World Forum for Harmonization of Vehicle Regulations

Working Party on Automated/Autonomous and Connected Vehicles

Vehicle subcategories for ADS

Proposal for new vehicle subcategories for vehicles equipped with automated driving systems

Figure 1
Proposed vehicle categorization under R.E.3

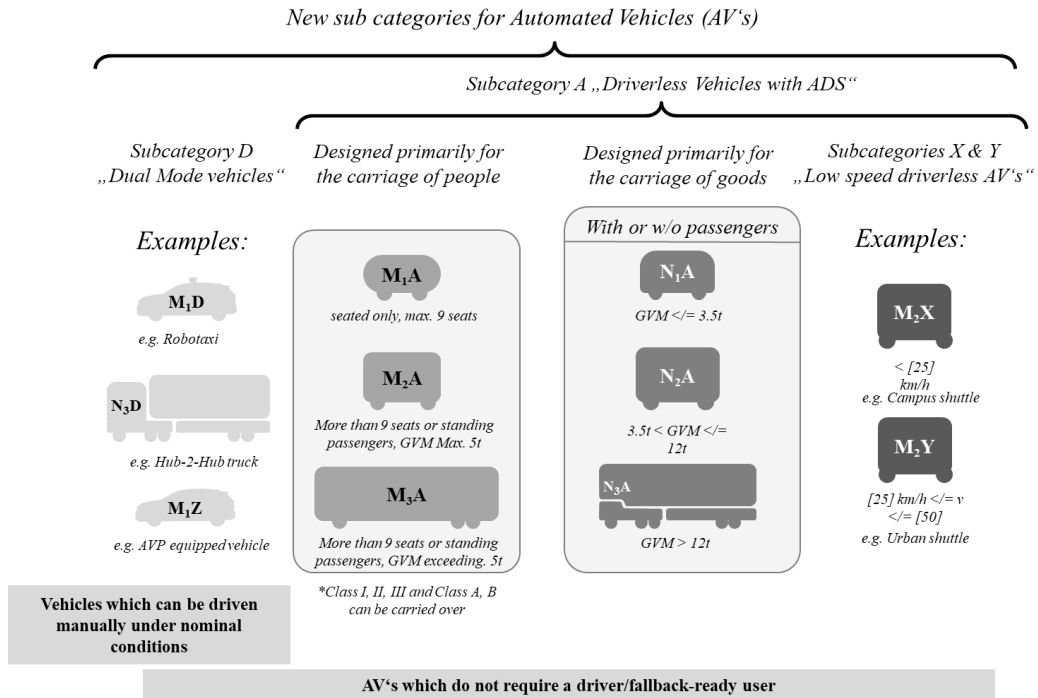
- (a) Modifications to the existing text of R.E.3, i.e. to “Category M - Power-driven vehicles having at least four wheels and used for the carriage of passengers in paragraph”,
- (b) Addition of two new main subcategories, Category A for “driverless automated vehicles” and Category D for “dual mode vehicles”,
- (c) Introduction of three additional subcategories, Category X and Y for “low speed driverless vehicles”, and Category Z for “low speed dual mode vehicles”

13. An overview of the different subcategories proposed is provided in Figure 1 below.
